# St. Peters Anglican College, Community Hub, Sports & Recreation Centre Project

Eurobodalla Shire Council  
Request for Information (RFI) Report

**Application No.** DA0078/23

**Description:** Alterations and additions to existing educational establishment

STAGE 3 (2025 - 2026)

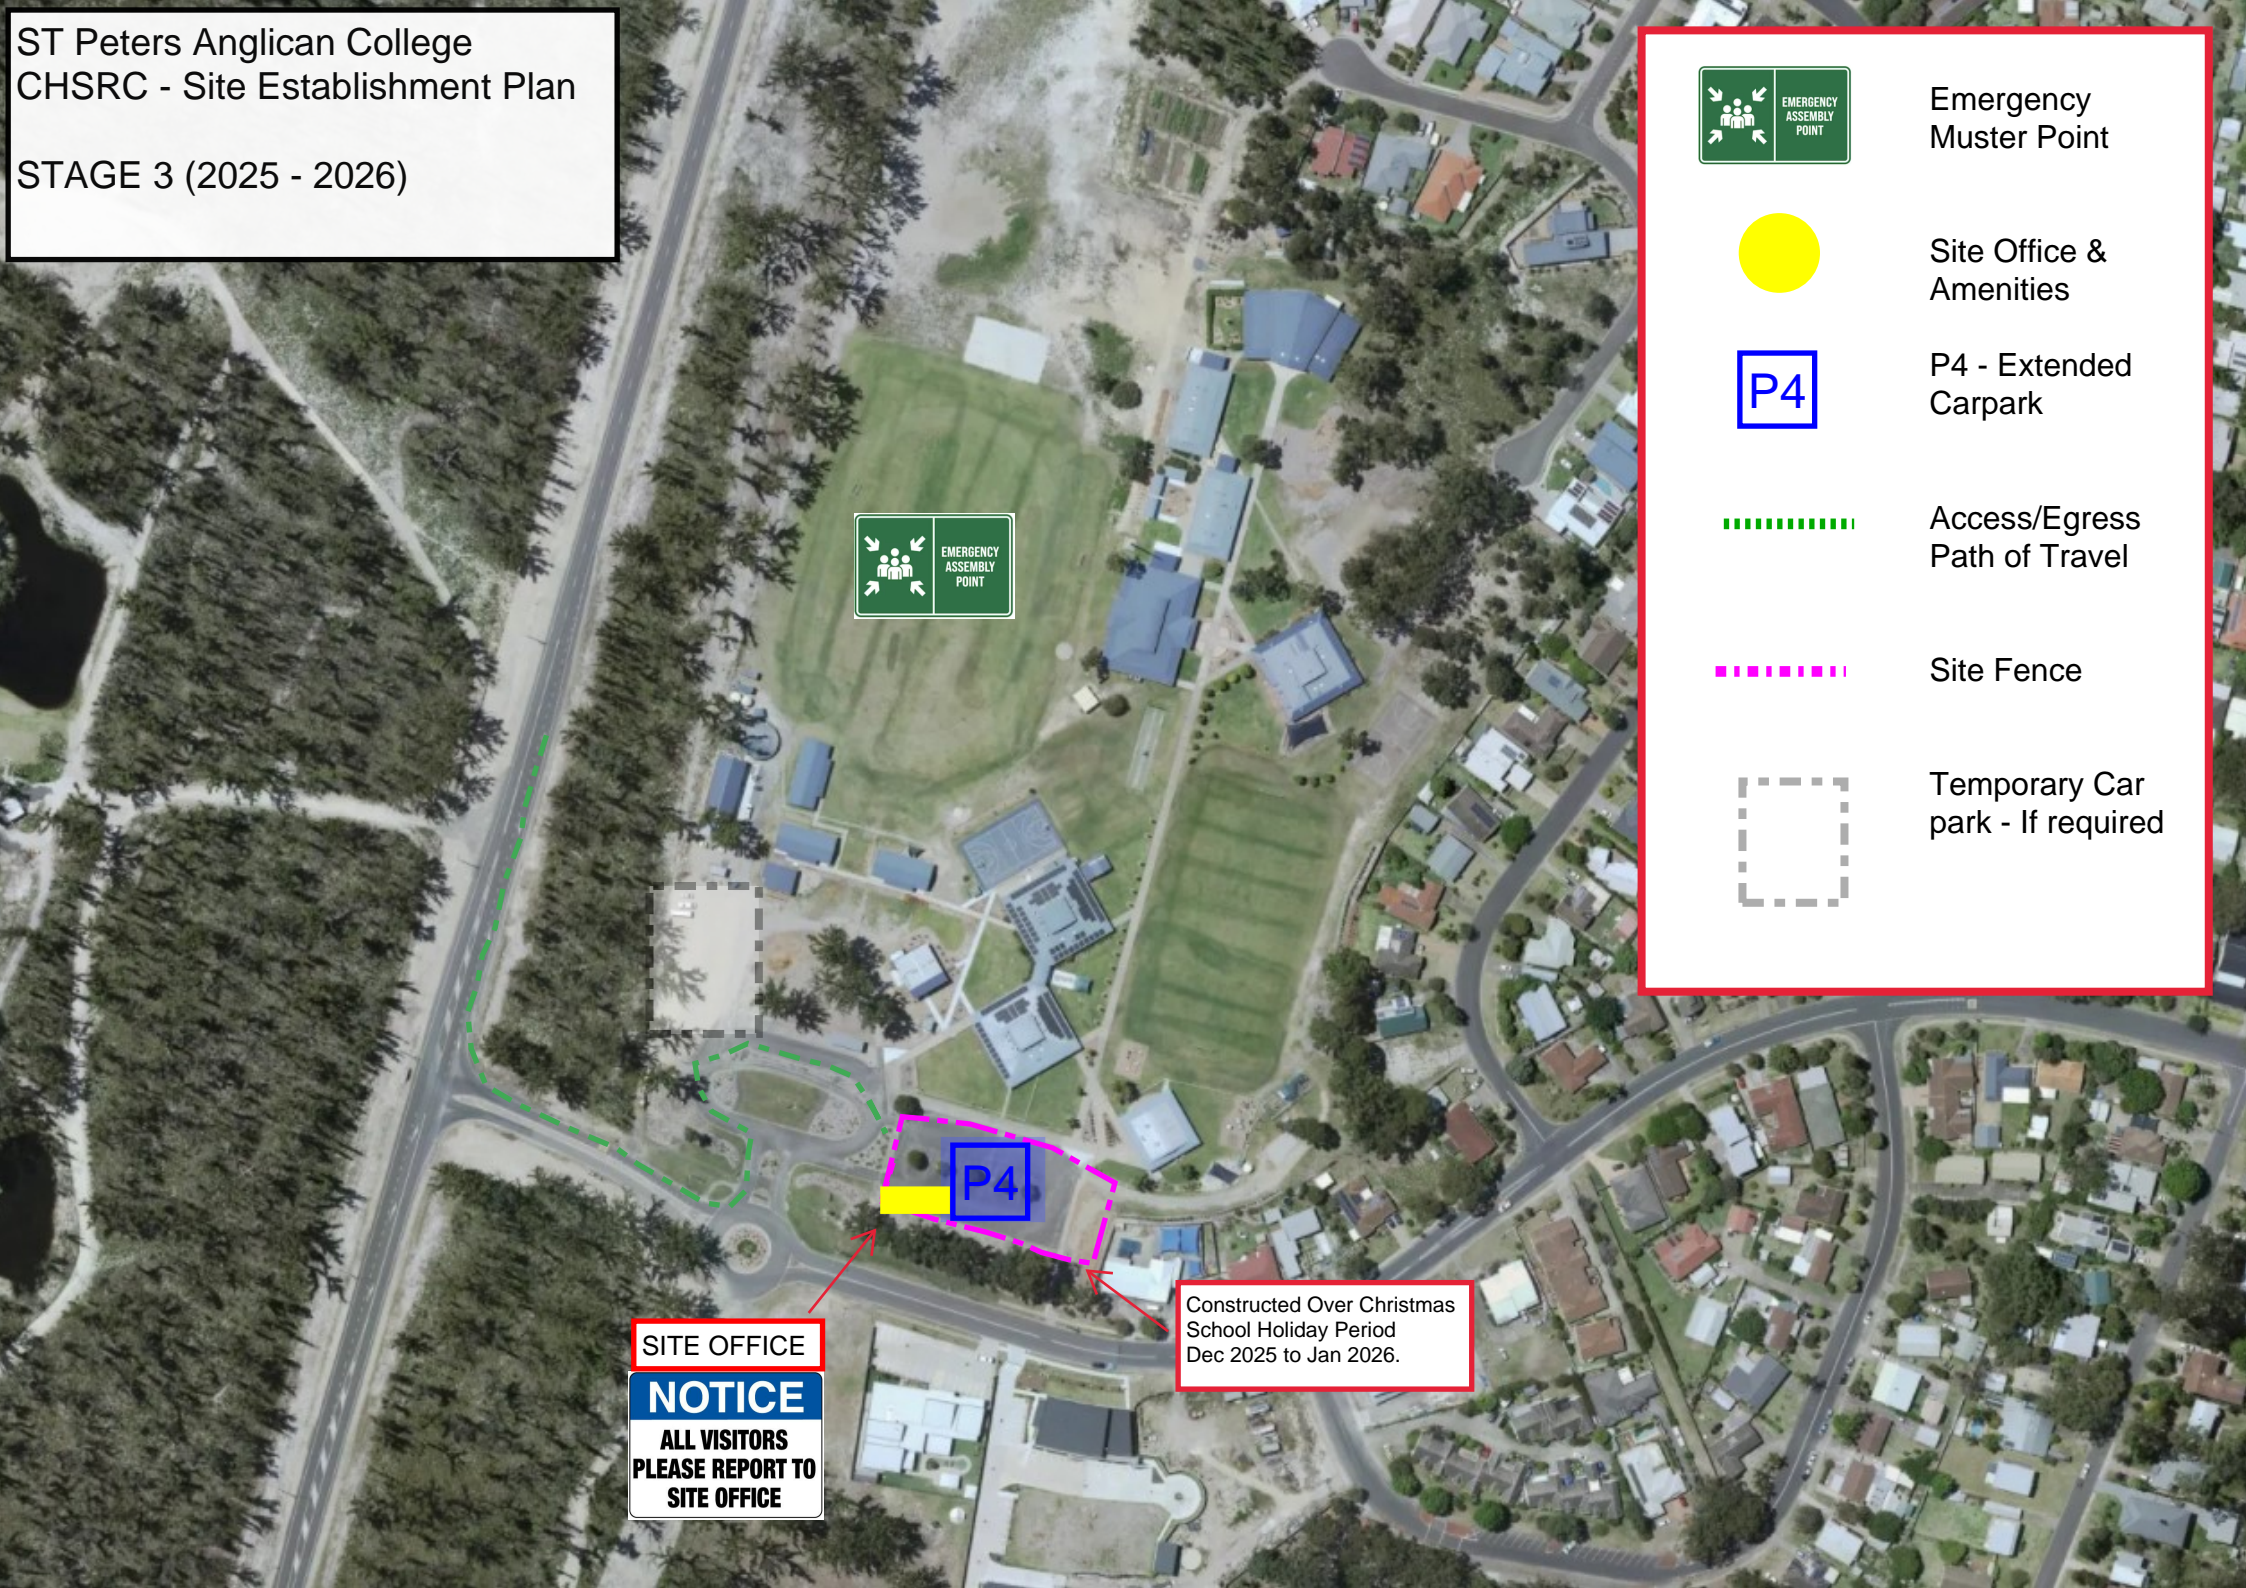
Temporary Car  
park - If required

Constructed Over Christmas  
School Holiday Period  
Dec 2025 to Jan 2026.
